Appendix X: Public Comments  
Received with DOH-CAB Responses  
and Final Permit Amendments

# Comments Received

**Subject:           Regional Haze Draft State Implementation Plan Comments**  
**Hawaiian Electric Company, Inc.**  
**Maui Electric Company, Ltd.**  
**Hawai'i Electric Light Company, Inc.**

**Figure 1.3-2** Volcanoes National Park Visibility Monitoring Sites (IMPROVE Site HAVO1)

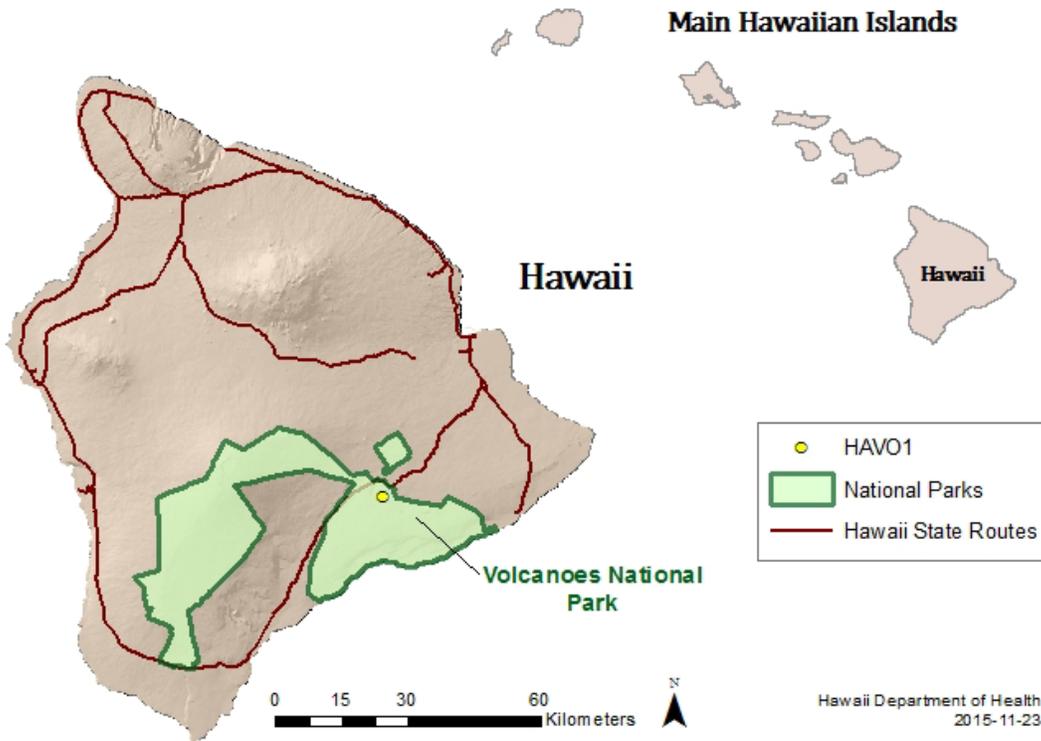
In some locations in the text of the draft SIP, the name of Hawai'i Volcanoes National Park is incorrectly given as "Volcanoes National Park." These locations include the list of figures (for Figure 1.3–2), in Table 1.2–1 page 3, and in the title of Figure 1.3–2 on page 5. Please correct these with the full park name "Hawai'i Volcanoes National Park."
